MINUTES MHCC STRUCTURE & DESIGN SUBCOMMITTEE MEETING

December 10, 2015

MANUFACTURED HOUSING CONSENSUS COMMITTEE (MHCC) STRUCTURE & DESIGN SUBCOMMITTEE MEETING

APPENDIX B: PROPOSED MODIFICATION TO LOG 87

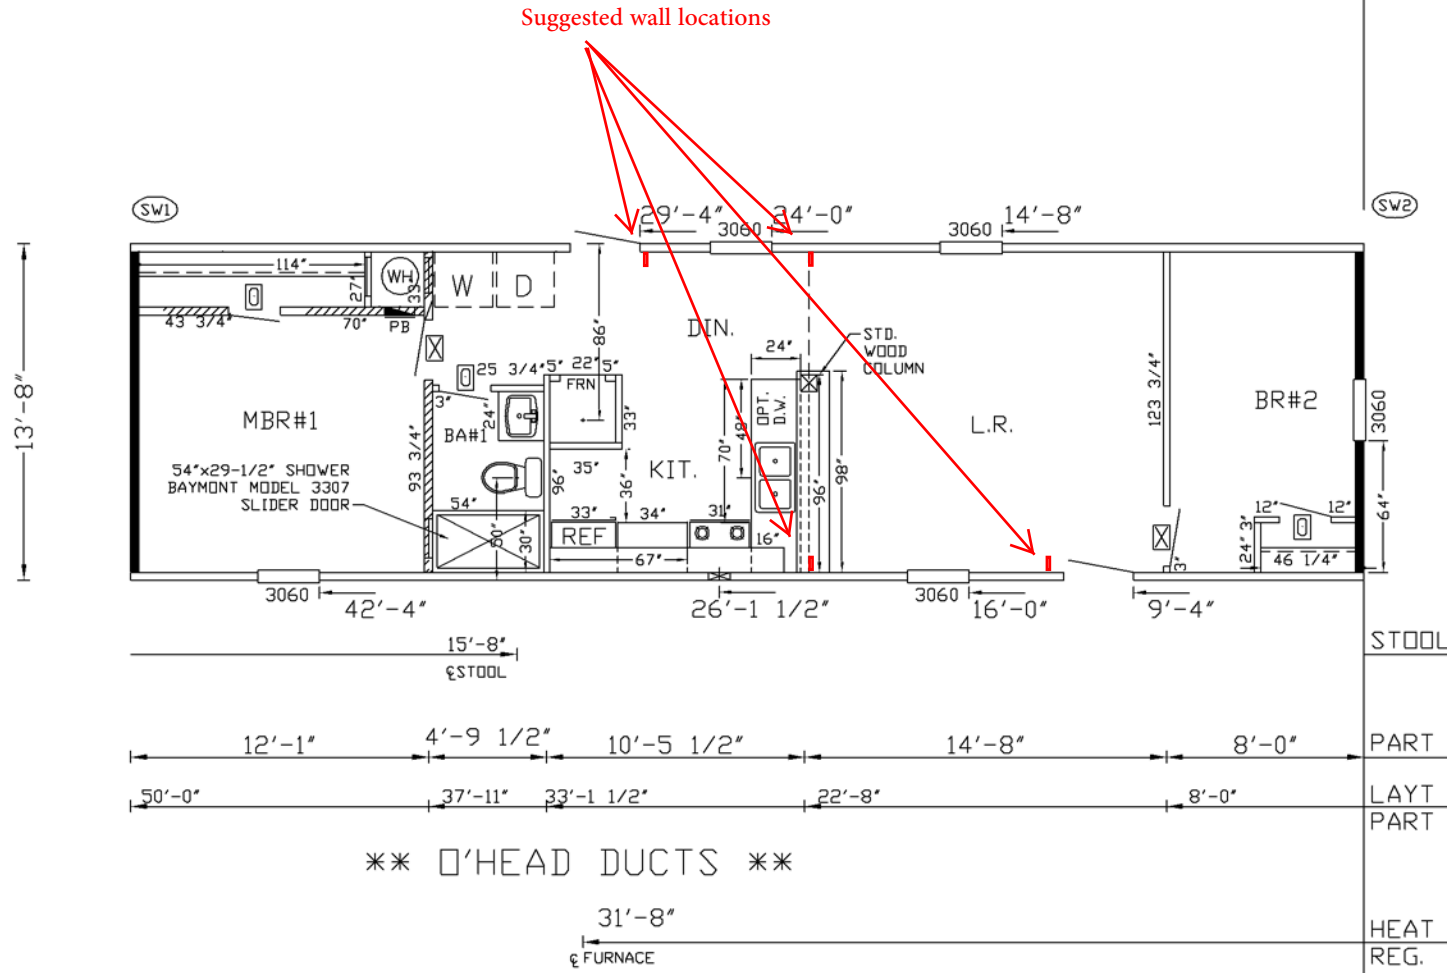
desire more open floor plans so that the whole family can be together no matter which room they're using. The housing market demands open floor plans with rooms which are not defined by walls. Current interpretation of code requires a minimum of a 6" long full height wall segment to be installed within open floor plans in order to meet the "not in the same room or in a group of rooms which are not defined by fixed walls" requirement. Homeowners do not want these stub wall obstructions in their homes which provide no advantage in fire safety. Furthermore, the current language increases liability since room division is not defined within 3280 and therefore the 6" wall segment which is currently accepted by interpretation of this section is subject to legal dispute.

NTA recently received a deviation from HUD, and was unsuccessful in disputing it concerning floor plans similar to this one HUD is insisting that a full height at one of the locations show in order to provide a 'seperation' between the exterior doors.
